# Historical Affairs and Landmark Review Board

## HALRB Meeting February 15, 2023, CoA22-14A

**2317 N. Kenmore St.:** A request to modify CoA 22-14 to increase roof ridge height by 4' and add a dormer in rear.

**NEW NORTH SIDE ELEVATION**

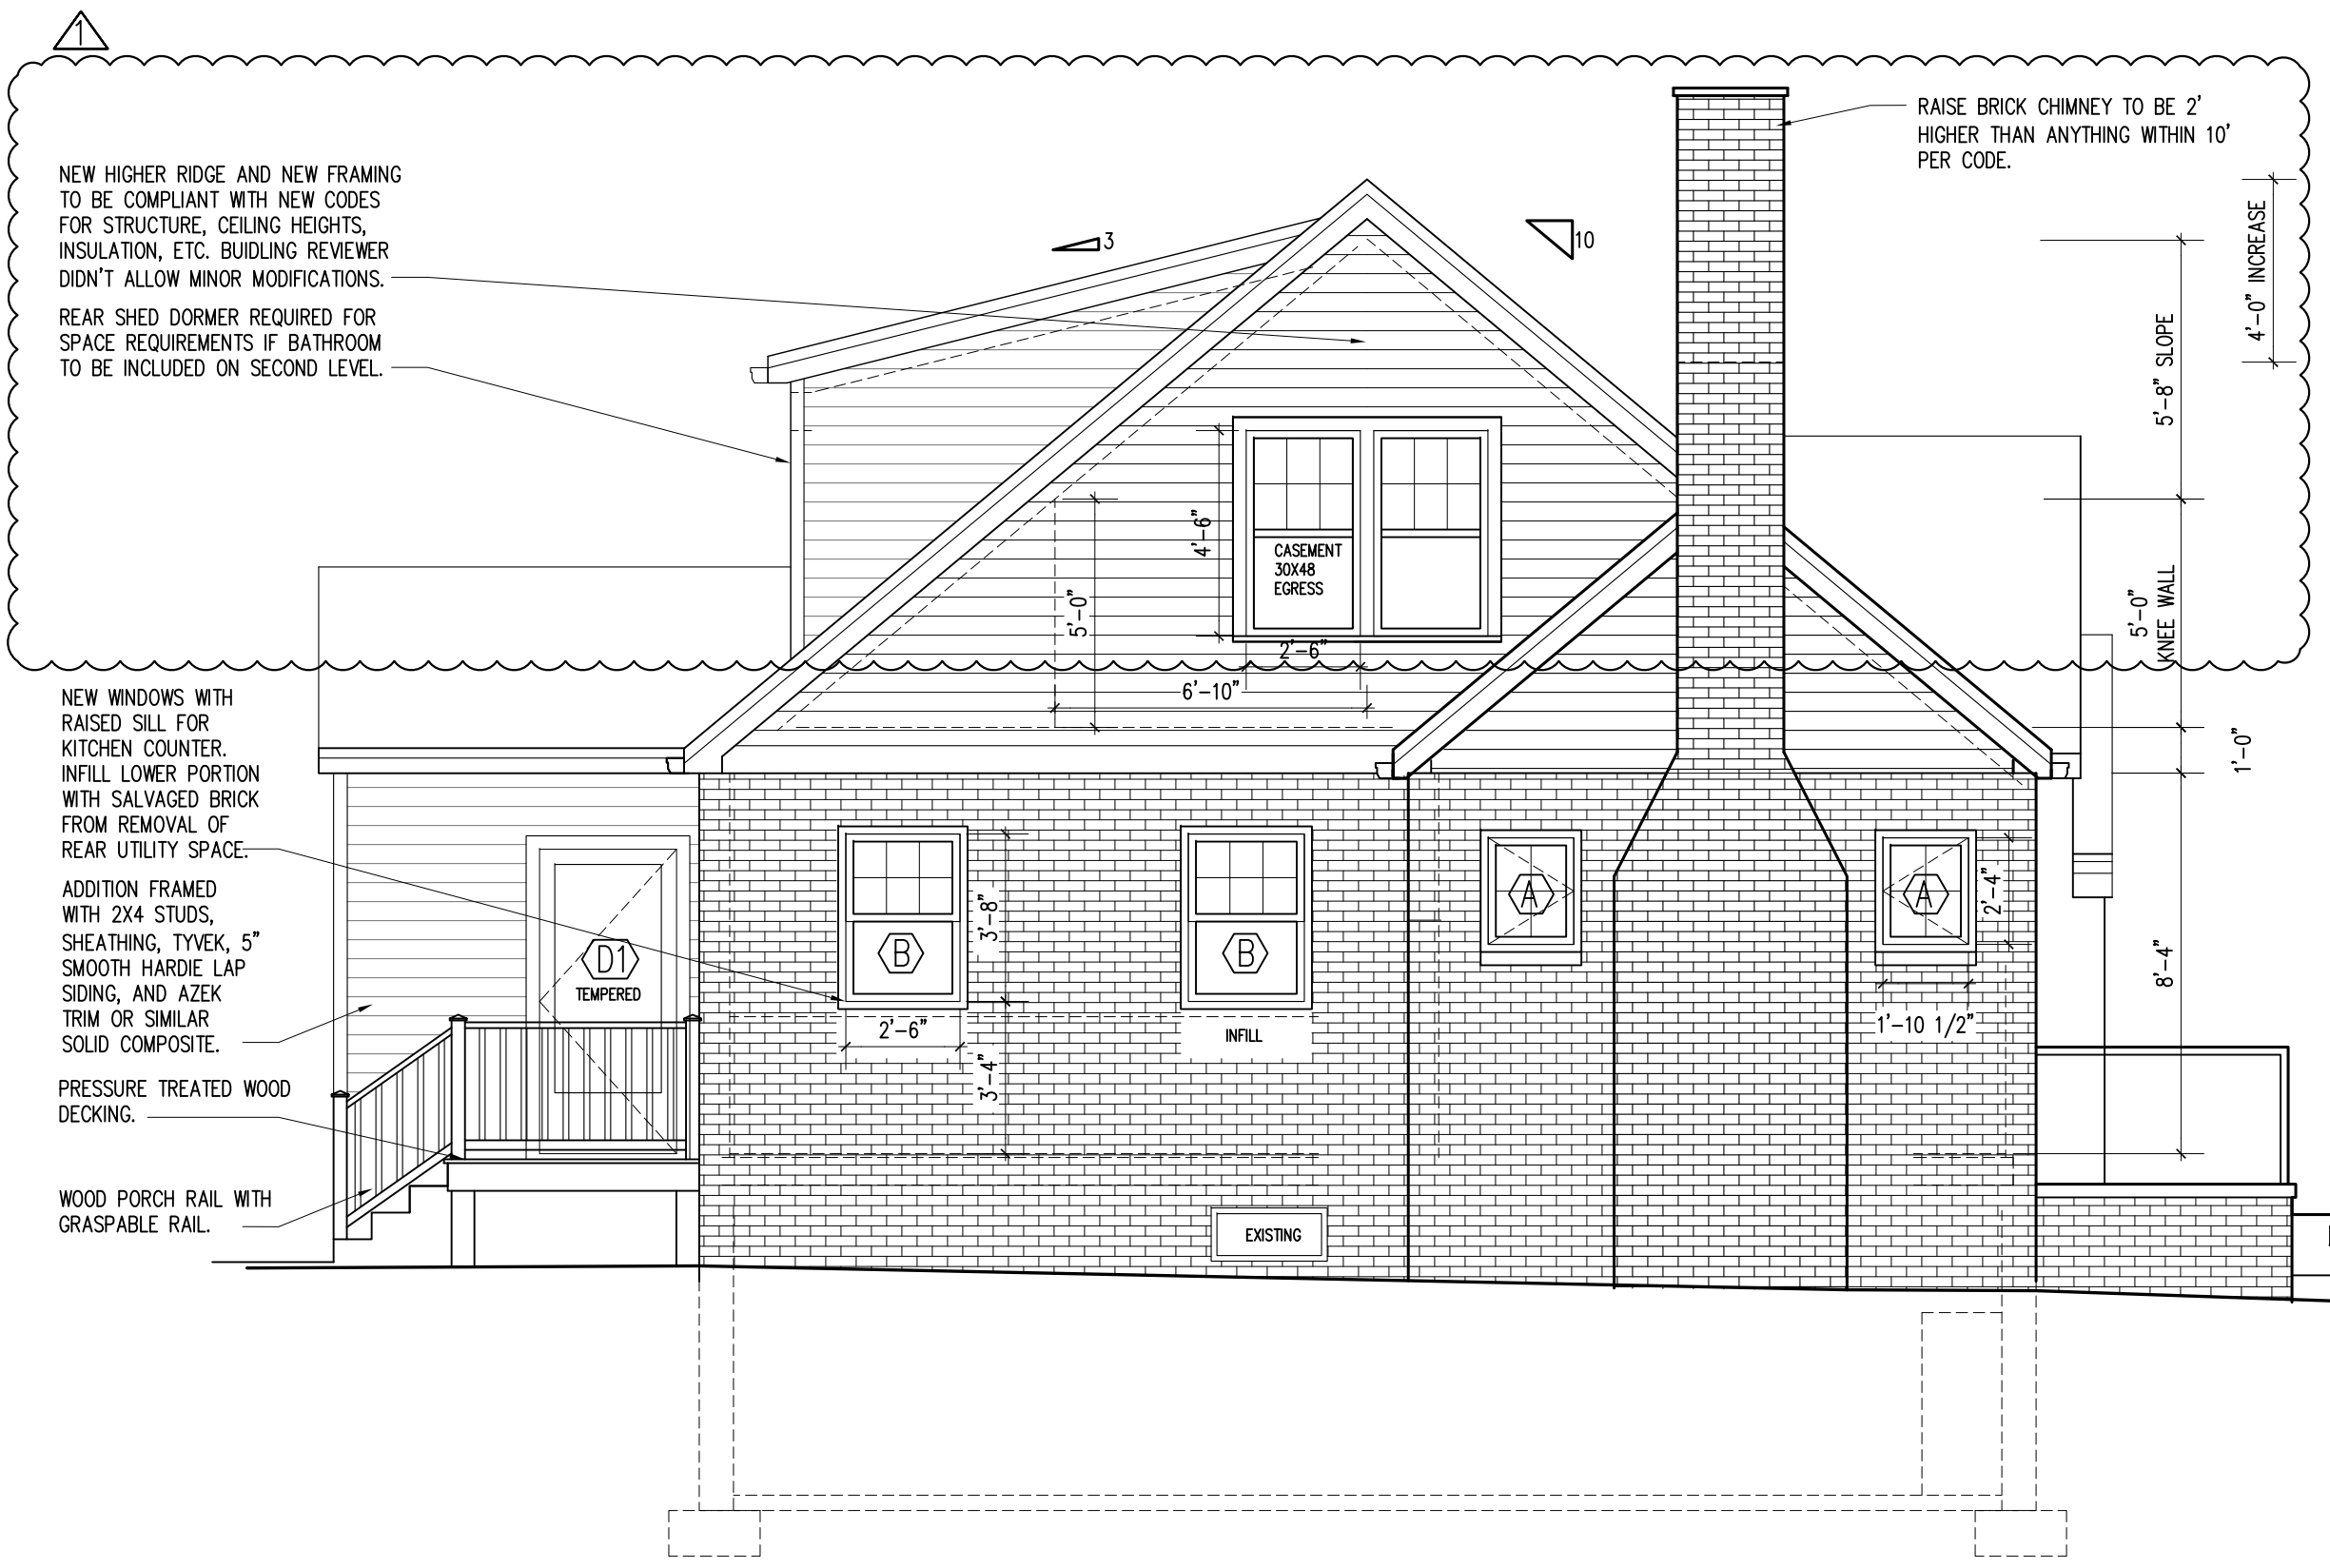
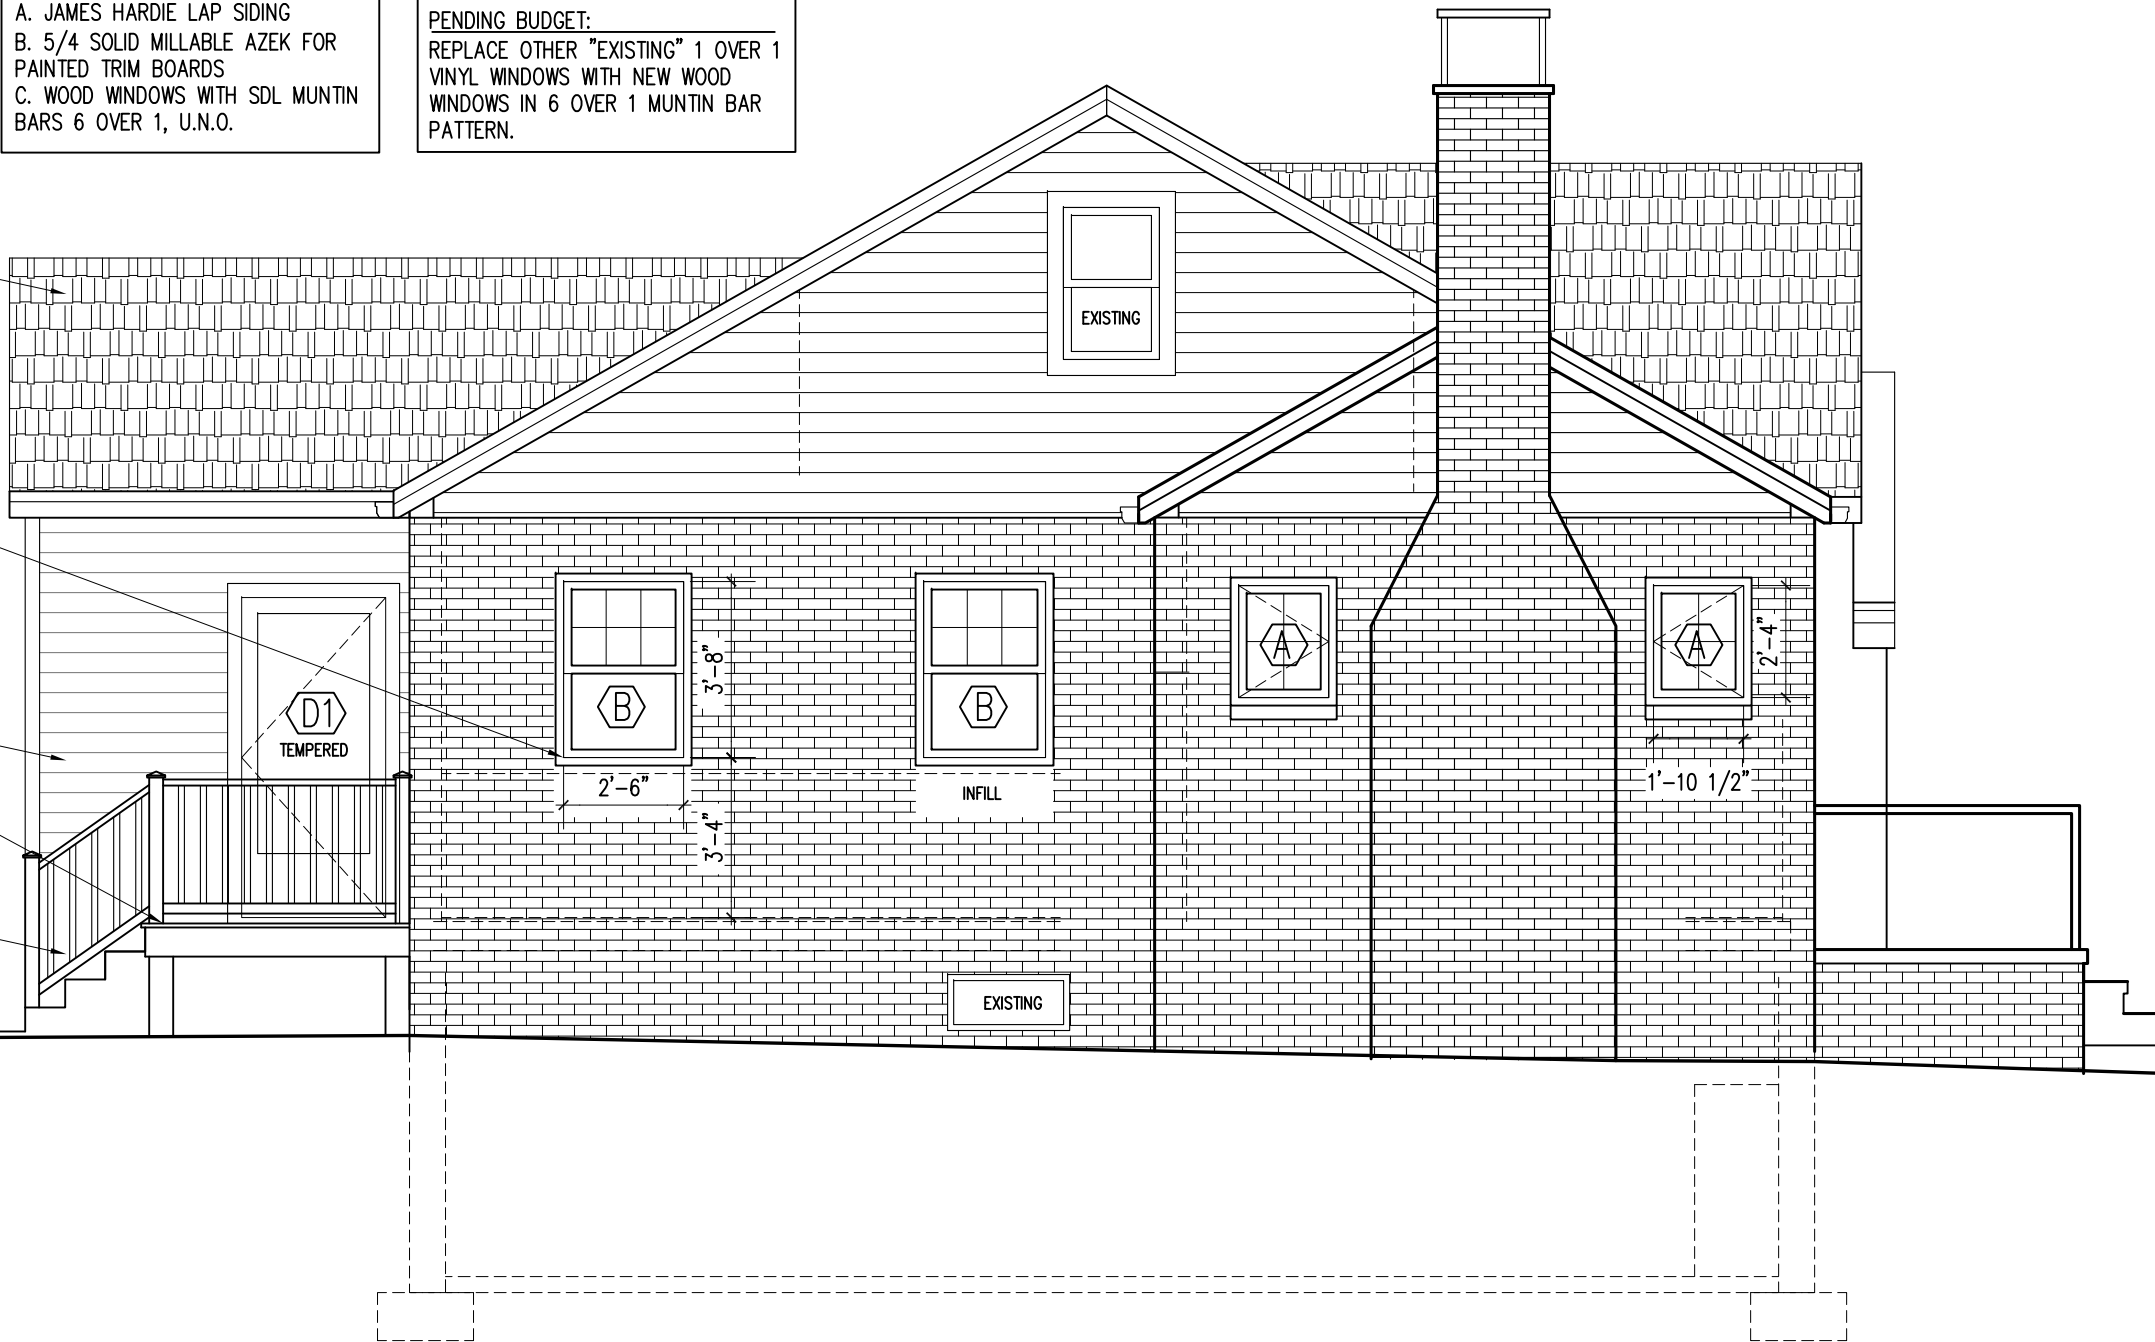
NEW HIGHER RIDGE AND NEW FRAMING TO BE COMPLIANT WITH NEW CODES FOR STRUCTURE, CEILING HEIGHTS, INSULATION, ETC. BUILDING REVIEWER DIDN'T ALLOW MINOR MODIFICATIONS.

REAR SHED DORMER REQUIRED FOR SPACE REQUIREMENTS IF BATHROOM TO BE INCLUDED ON SECOND LEVEL.

**1 - SECTION THROUGH STAIR**

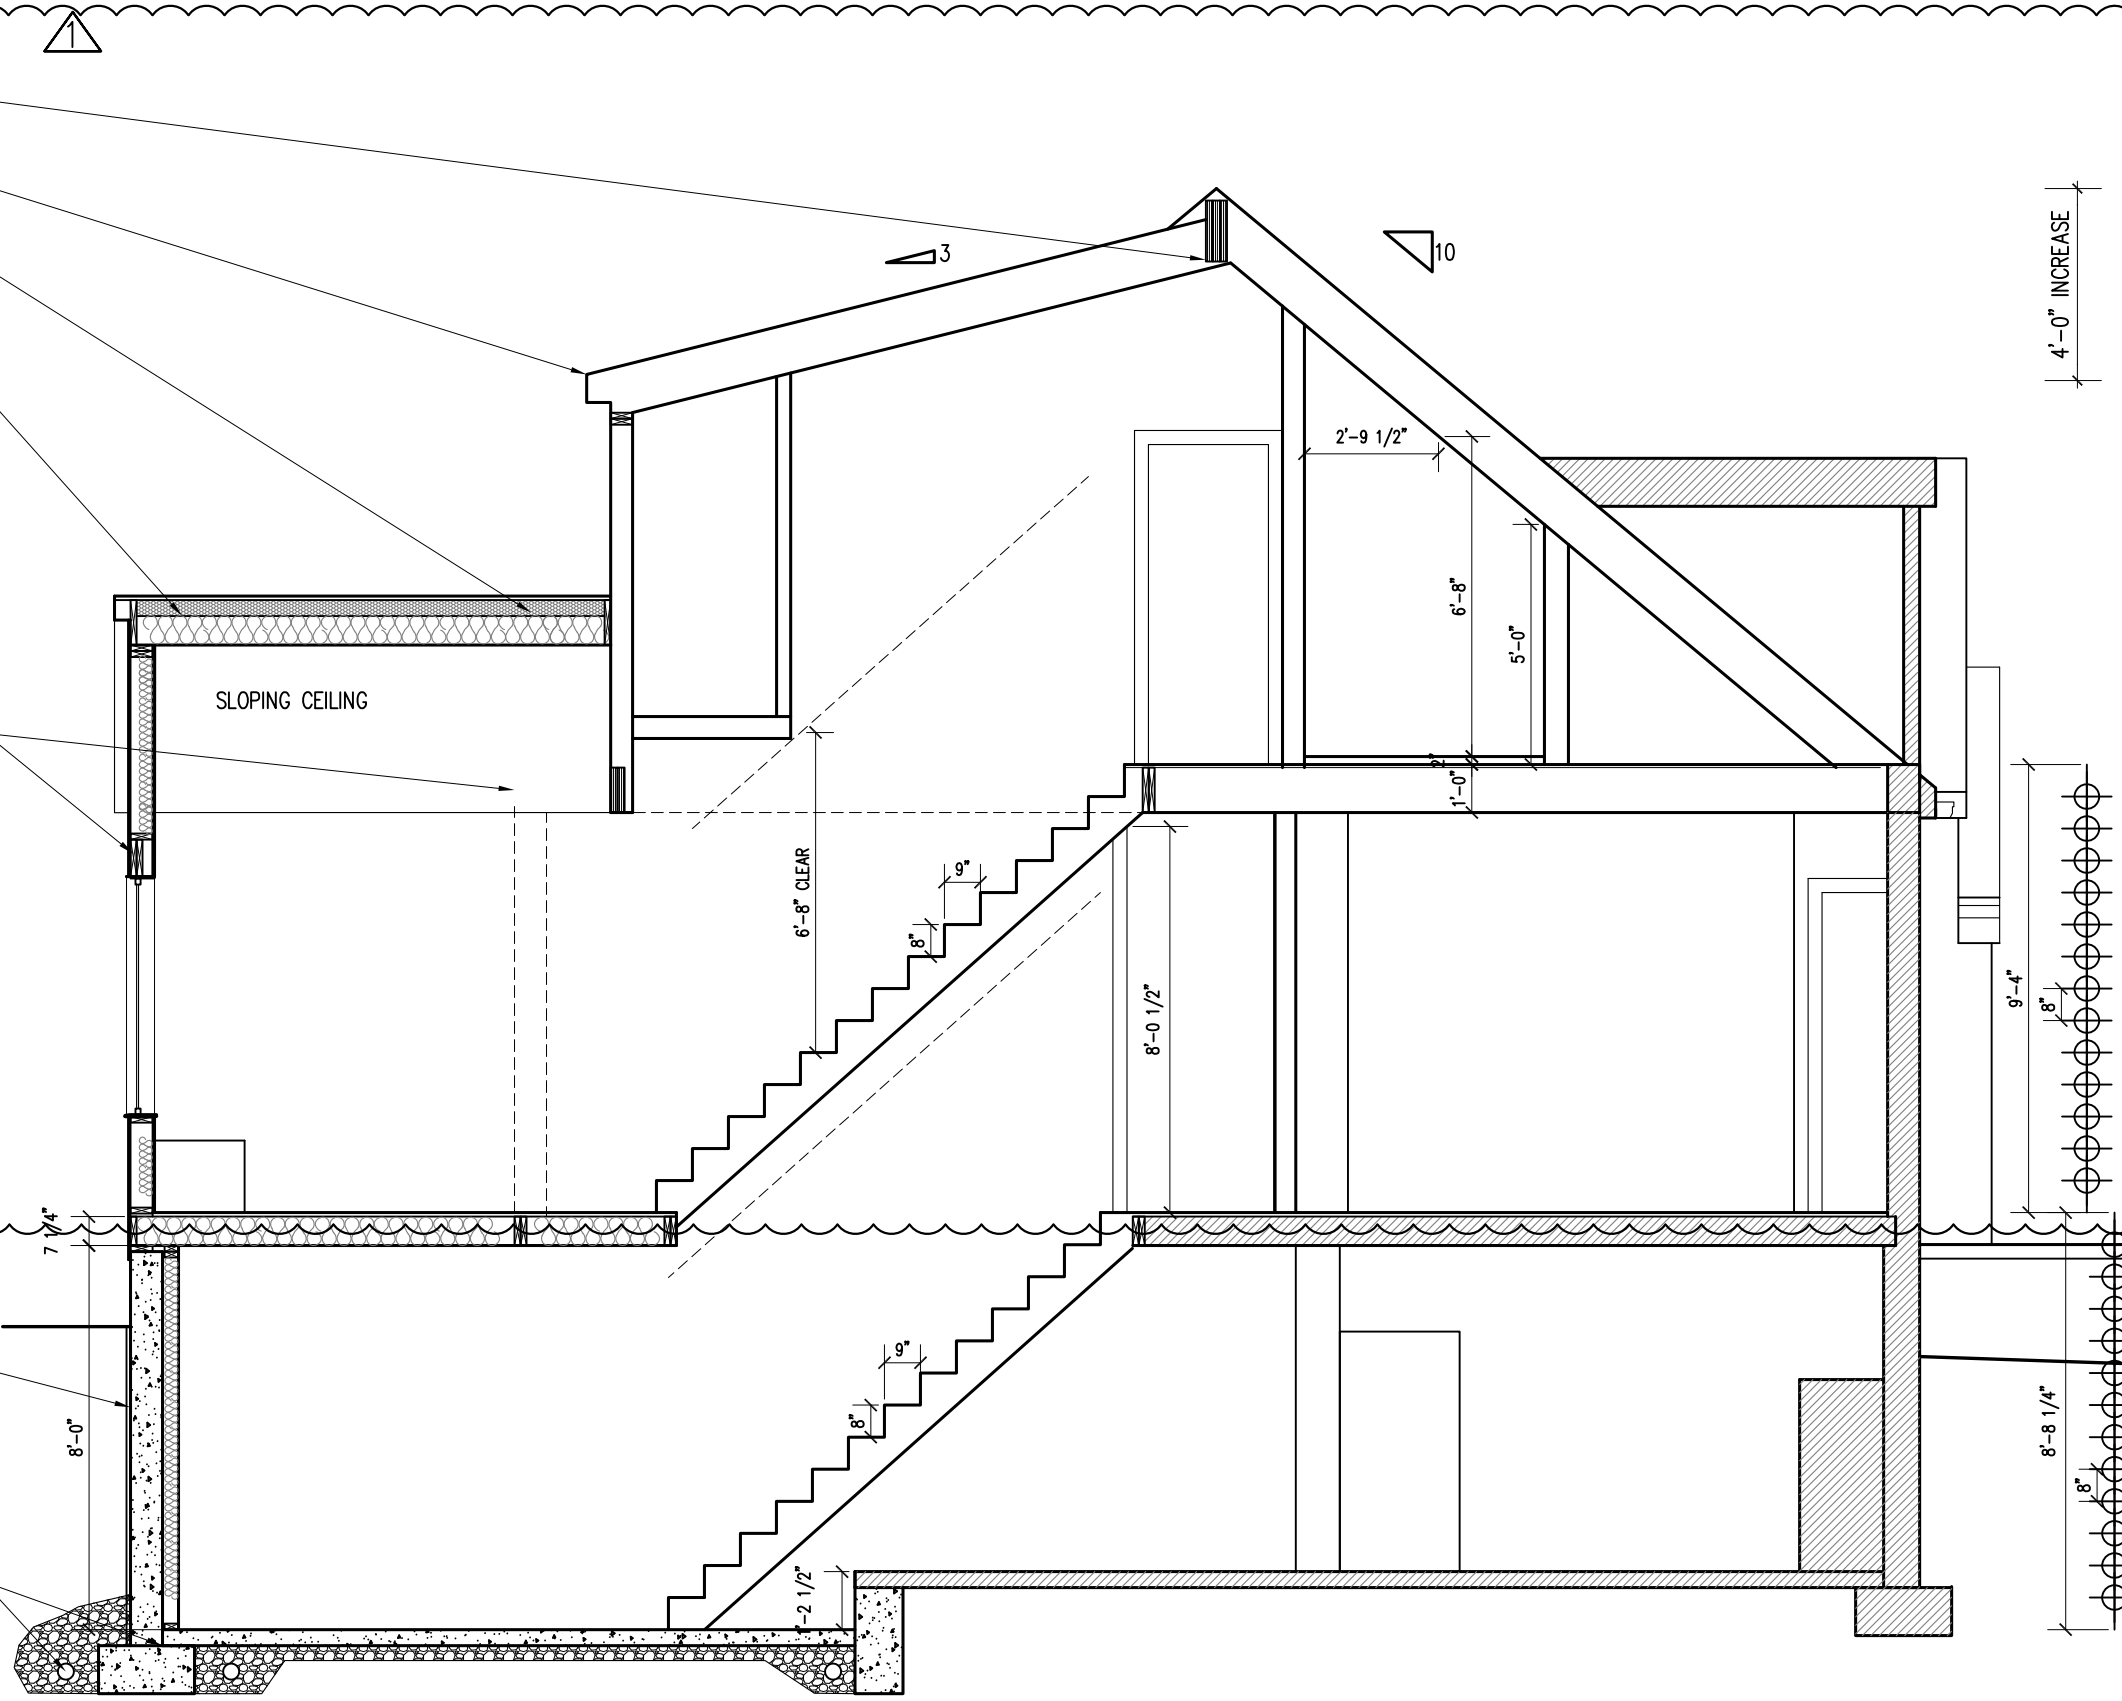
NEW HIGHER RIDGE BEAM AND NEW 2X FRAMING PER CODE COMPLIANCE FOR STRUCTURE, HEIGHTS, AND INSULATION ISSUES.

REAR DORMER CONT. IF BATHROOM IS INCLUDED ON SECOND FLOOR IN DESIGN FOR SPACE REQUIREMENTS.
